U.S. Environmental Protection Agency Region 10,
Supplemental Response to Comments for Outer Continental Shelf
Prevention of Significant Deterioration Permits, Noble Discoverer
Drillship, Shell Offshore Inc., Beaufort Sea Exploration Drilling
Program, Permit No. R10OCS/PSD-AK-2010-01, Shell Gulf of Mexico
Inc., Chukchi Sea Exploration Drilling Program,
Permit No. R10OCS/PSD-AK-09-01
(Sept. 19, 2011)

**SUPPLEMENTAL RESPONSE TO COMMENTS
FOR
OUTER CONTINENTAL SHELF
PREVENTION OF SIGNIFICANT DETERIORATION PERMITS
NOBLE DISCOVERER DRILLSHIP**

**SHELL OFFSHORE INC.
BEAUFORT SEA EXPLORATION DRILLING PROGRAM
PERMIT NO. R10OCS/PSD-AK-2010-01**

**SHELL GULF OF MEXICO INC.
CHUKCHI SEA EXPLORATION DRILLING PROGRAM
PERMIT NO. R10OCS/PSD-AK-09-01**

Figure 1. Region 10 Supplemental 1-Hour NO₂ Modeling Analysis Using 100 Meter and 25 Meter Receptor Spacing

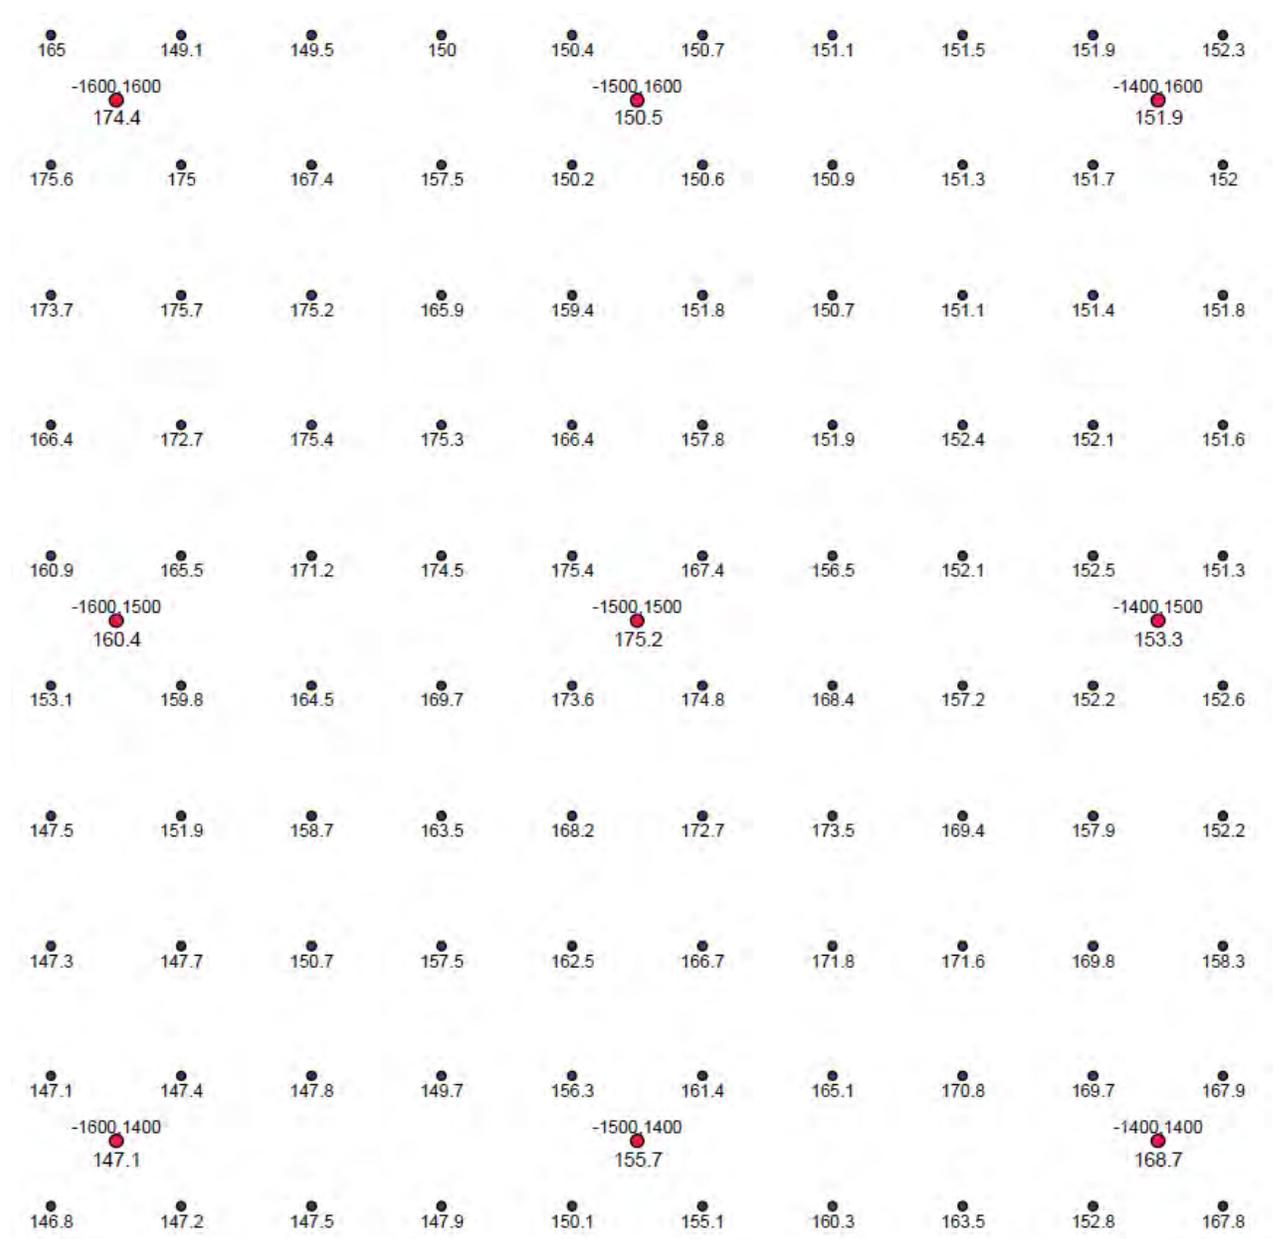
Comment W.2: Commenters assert that Region 10 must require Shell to remodel its impact on 1-hour NO₂ concentrations in the Chukchi Sea using a higher density of receptors and that the approach used by Shell may have missed identifying the maximum projected impacts from Shell’s proposed operations. The commenters contend that it is well-established protocol among air agencies that ambient air modeling should include the placement of additional receptors in the vicinity of projected maximum impacts to ensure that the model does not miss the true maximum. As support, they state that the Alaska Department of Environmental Conservation (ADEC) recommends a 25 meter spaced grid surrounding the receptor with the maximum impact to ensure the maximum has truly been defined. Because the maximum 1-hour NO₂ impact in the Chukchi Sea is predicted to occur at 1.5 kilometers from the center of the Discoverer rather than at 500 meters, the commenters contend, Shell did not have a sufficient density of receptors in the location of the predicted maximum impact. The commenters assert that Shell had a spacing of 250 meters at this distance, whereas other permitting agencies would have required a spacing of 25 meters. By failing to model with sufficient receptor points around the location of maximum projected impact, the commenters state, Shell has failed

to account for the true magnitude of the impacts of its NO₂ emissions upon air quality. In fact, the some commenters contend, their modeling expert reviewed Shell's analysis and performed an additional modeling runs revealing a cluster of elevated 1-hour NO₂ concentrations, including numerous receptors registering a level that would exceed 188 µg/m³ when added to the background concentrations for that hour. The commenters allege that this shows that the 98th percentile concentration reported by Shell in the permit application is underestimated and will be higher with additional receptors at 100 m resolution and, since the existing total impact of 174 µg/m³ is close to the NAAQS of 188 µg/m³, it is highly likely that this standard can be exceeded with higher concentrations at these additional receptors. The commenters ask that Region 10 require Shell to rerun its models with additional receptors in the region between 1 and 5 kilometers and that if Shell's additional modeling reveals a NAAQS violation, additional controls must be imposed upon Shell's operations. This is necessary, the commenters assert, to ensure that Shell, as an OCS source, is held to the same requirements "as would be applicable if the source were located in the corresponding onshore area."

Response: In response to these comments, Region 10 repeated the AERMOD modeling run performed by Shell in the Chukchi Sea for the 1-hour NO₂ NAAQS to include a 100 meter receptor spacing domain wide with a 25 meter receptor spacing centered on the highest modeled receptor identified in the Shell modeling and verified in the Region 10 analysis. Region 10 also used the latest regulatory version of AERMOD, version 11103, in this revised analysis. Results for the receptors that are in common in the Shell and Region 10 modeling indicate slightly higher 1-hour NO₂ concentrations when using the latest version of AERMOD. In the prior Shell analysis, the highest modeled impact (including background) in the Chukchi Sea occurred at receptor (-1500, 1500) and was 174.0 µg/m³. In the revised Region 10 analysis using the latest version of AERMOD, the concentration at this receptor is 175.2 µg/m³, an increase of 1.2 µg/m³. Region 10 also reviewed the additional 100 meter spaced receptors and determined that receptor (-1500, 1500) was still the high on the domain. Region 10 then reviewed the 25 meter receptor grid that was placed over the (-1500, 1500) receptor and found a maximum modeled concentration of 175.7 µg/m³.¹⁸

Figure 1 provides an overview of the modeling results that Region 10 performed. Red receptors are those receptors spaced at 100 meters with modeled concentrations labeled below the receptor. Black receptors are the additional 25 meter spaced receptors placed over the domain-wide modeled maximum (receptor -1500, 1500 in case of the Chukchi Sea), with modeled concentrations labeled below the receptor. As discussed above, this analysis determined a maximum modeled concentration of 175.7 µg/m³, at receptor

(-1587.5, 1562.5). This additional analysis continues to indicate that the 1-hour NO₂ NAAQS will be protected.

Because the modeled differences, using additional receptors and the latest regulatory version of AERMOD, still demonstrate compliance with the NAAQS and have very similar concentrations to the prior Shell analysis, Region 10 believes no additional analysis, other than that provided here, is needed and that the commenter's concerns have been addressed.
